ASD Technology PRODUCT: T2 PCB NUMBER: T2-S-03513-V2-1 DESIGN ENGINEER: ASD		
Title 1-T2 Sensor board		
Size A	Document Number T2-S-03526-V2-1	Rev 2.1
Date: Tuesday, May 27, 2003		
Sheet 1 of 2

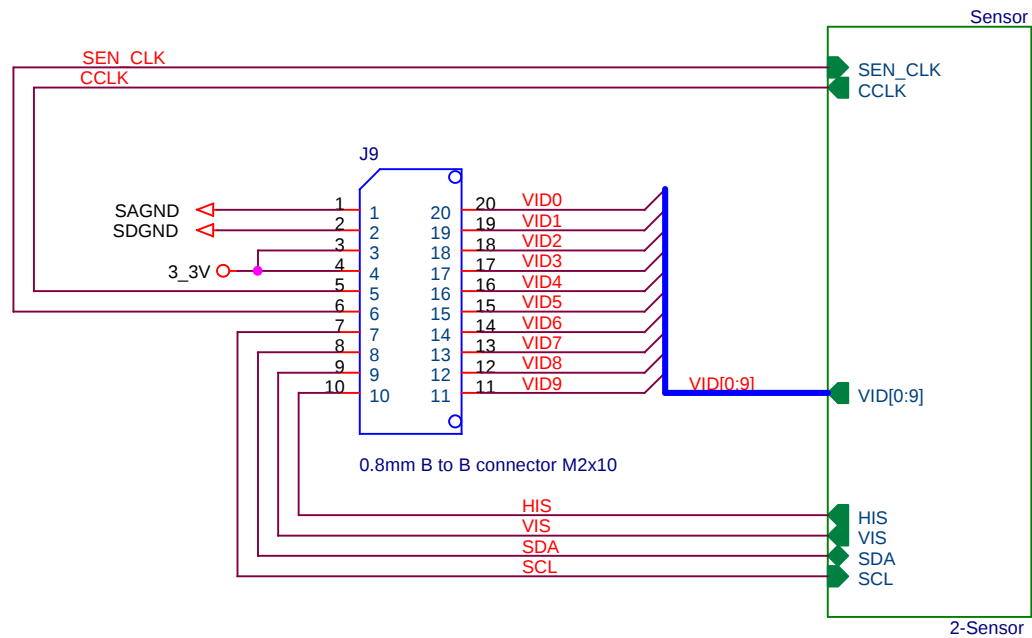
Move VCC , 3_3V , Pin 9 Change GND to
LGND , Pin 16 connect to GND
